# ARIZONA DEPARTMENT OF TRANSPORTATION

## INFORMATION BULLETIN 98-24

SUBJECT: Roadway Design Changes

## DETAIL LAYOUT FOR FLEAT-350

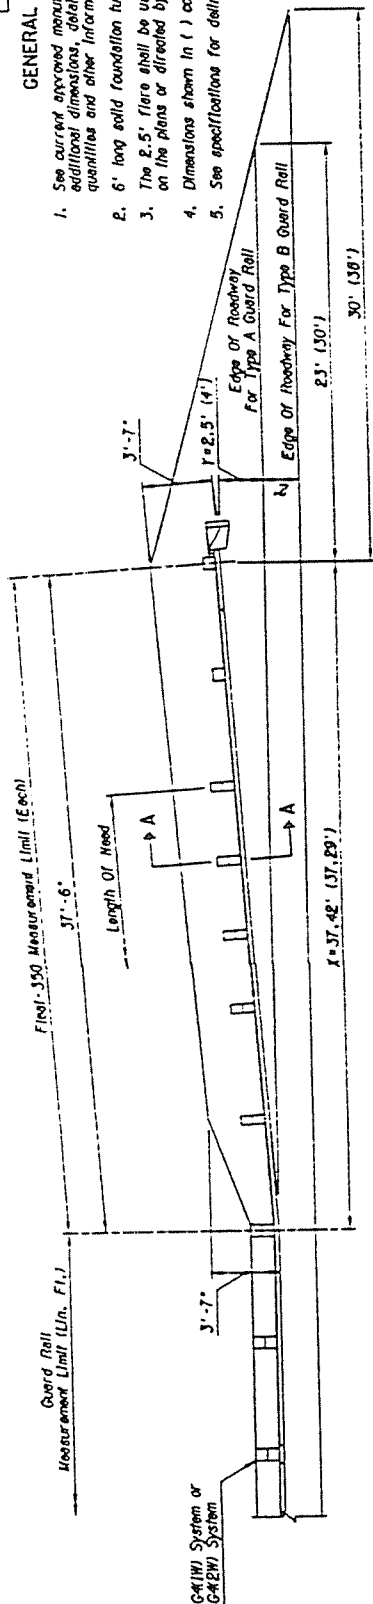
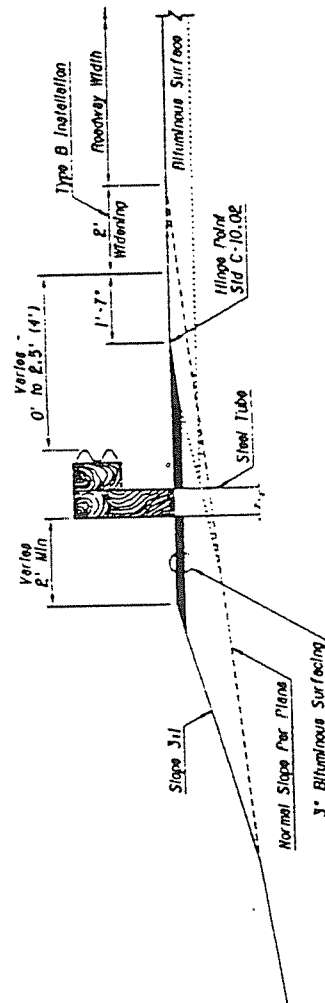
A Detail showing the Layout for FLEAT 350 is attached and should be included in the plans. Note that the straight flare shows an offset of either 2.5' or 4'; the 2.5' flare will be normal design offset and should be adequate for most applications. This is especially true when Type B guardrail is used (see General Note 3). Offsets greater than 2.5' and up to 4' may be specified on the plans if District requests additional offset for snow plowing or if determined by specific site conditions. Stored Specifications for the FLEAT 350 have been prepared by Contracts and Specifications Services and are available upon request.

The FLEAT 350 should be selected by the designer and shown on the plans as an alternate for locations where flared guard rail terminals are desired. Presently, the FLEAT 350 and the SRT 350 will be shown as bid alternates on the Barrier Summary Sheet. The Barrier Summary Sheet has been modified to accommodate this option. Flared guard rail terminals will normally be specified when there are shoulders less than 6' in width and where Districts desire flared guard rail terminals in snow plowing areas.
